Re: Office/Warehouse
8401 Firestone St. NE
Traffic Circulation Layout
Architect's Stamp 6-23-2023 (C17D013B3)

The revised TCL submittal received 7-14-2023 is approved for Building Permit by Transportation. A copy of the stamped and signed plan will be needed for each of the building permit plans. Please keep the original to be used for certification of the site for final C.O. for Transportation.

A NEW OFFICE / WAREHOUSE FACILITY
FOR MICK RICH CONSTRUCTION
8401 FIRESTONE LANE, N.E.
ALBUQUERQUE 2023 NEW MEXICO

SHEET NO.
ARCH-002

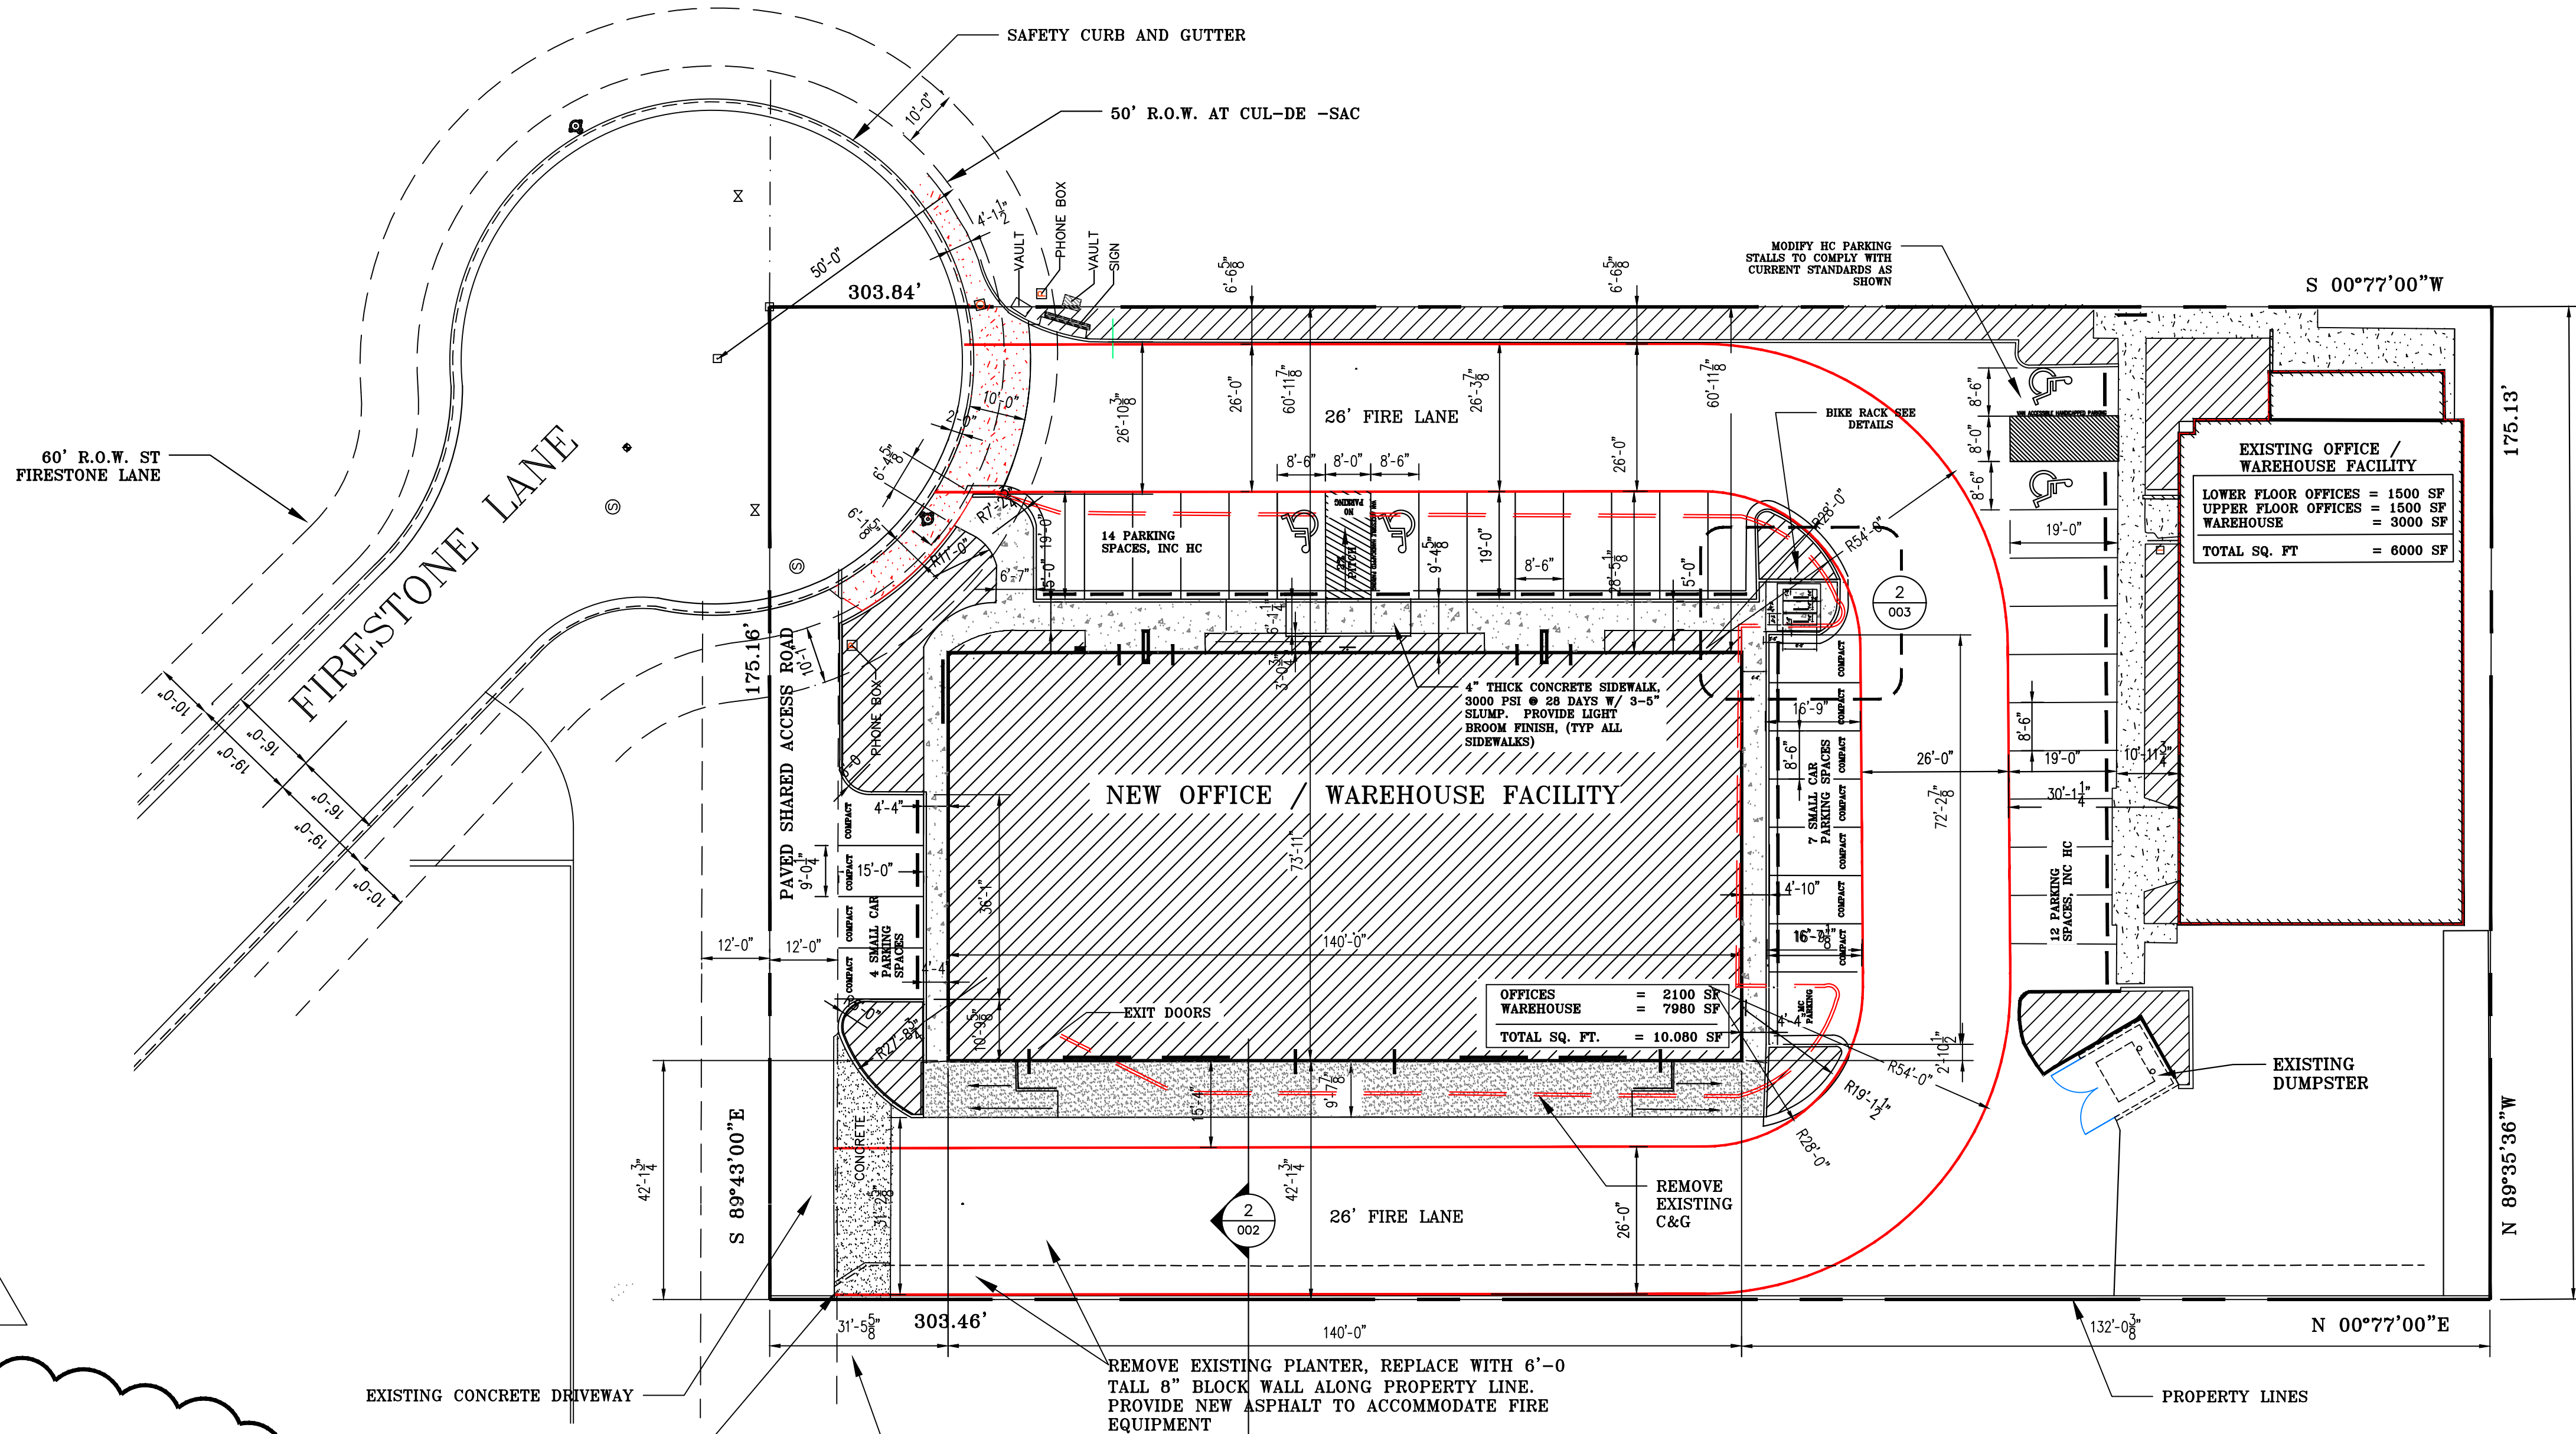
REVISIONS
1. REVISED HC SIDEWALK RAMP
